TRANS/WP.29/GRSP/2000/3/Rev.1
20 February 2004

World Forum for Harmonization of Vehicle Regulations (WP.29)

PROPOSAL FOR DRAFT AMENDMENTS TO REGULATION No. 44
(Child restraint systems)

Transmitted by the expert from Japan

"Annex 7 - Appendix 2-1
Curves of the trolley's acceleration as a function of time
Frontal impact

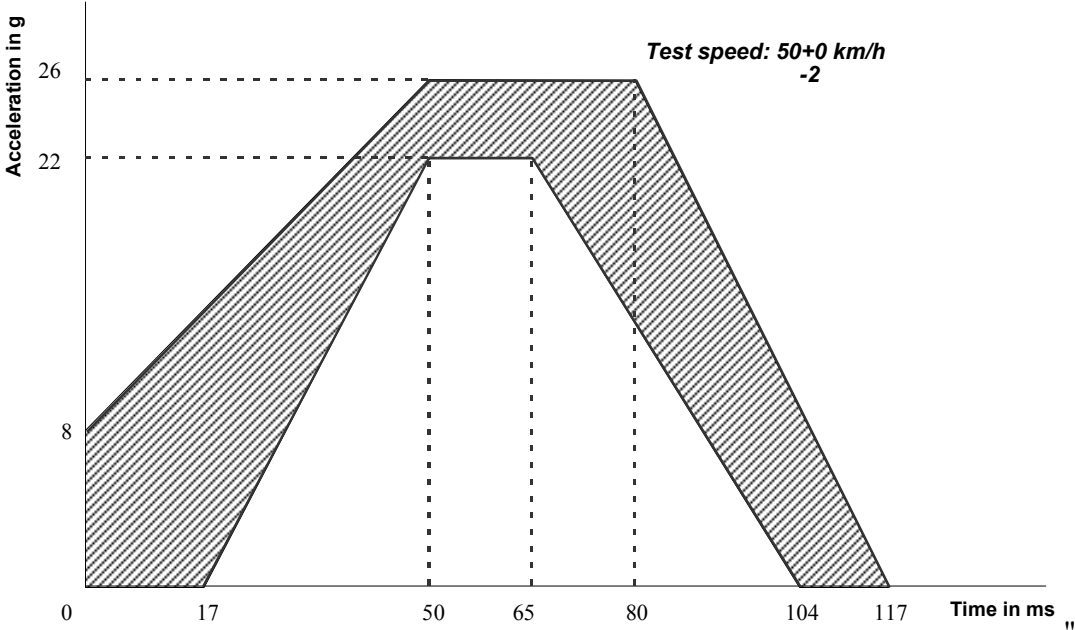
Insert a new Appendix 2-1., to read:

The corridor shown in annex 7 appendix 2-1 to this regulation has smaller limits compared with the existing corridor of deceleration device.

The new corridor has a width of $\pm 2g$ from the centre line while the existing corridor has one of $\pm 4g$. Timing of inflection point and slope are set the same in both corridors.

"Annex 7 - Appendix 2-2
Curves of the trolley's acceleration as a function of time
Rear impact

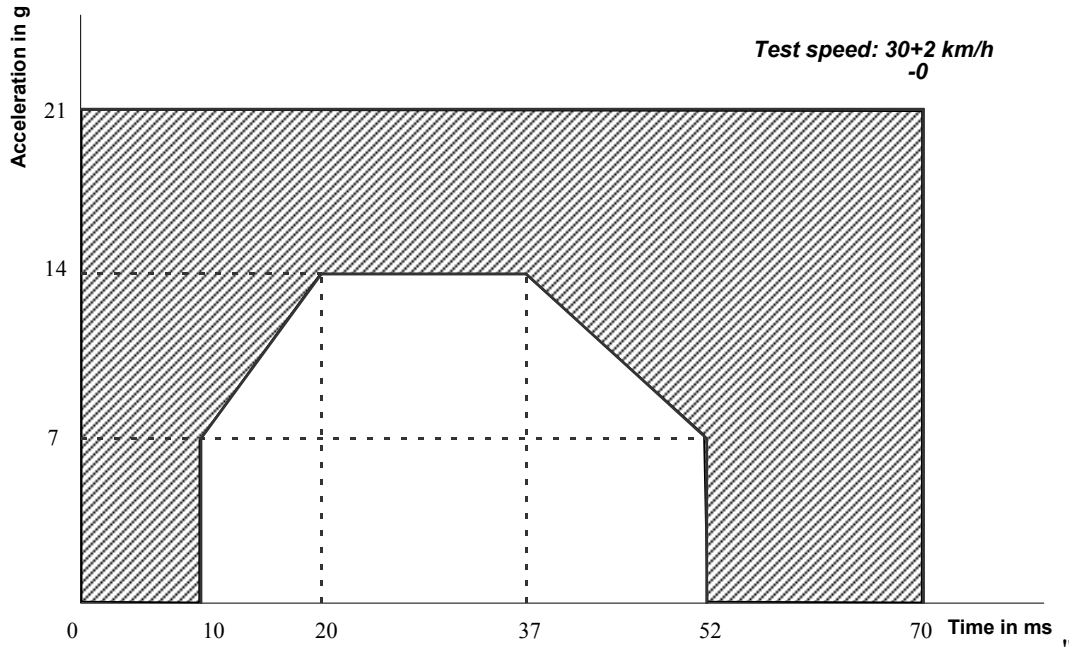
Insert a new Appendix 2-2., to read:
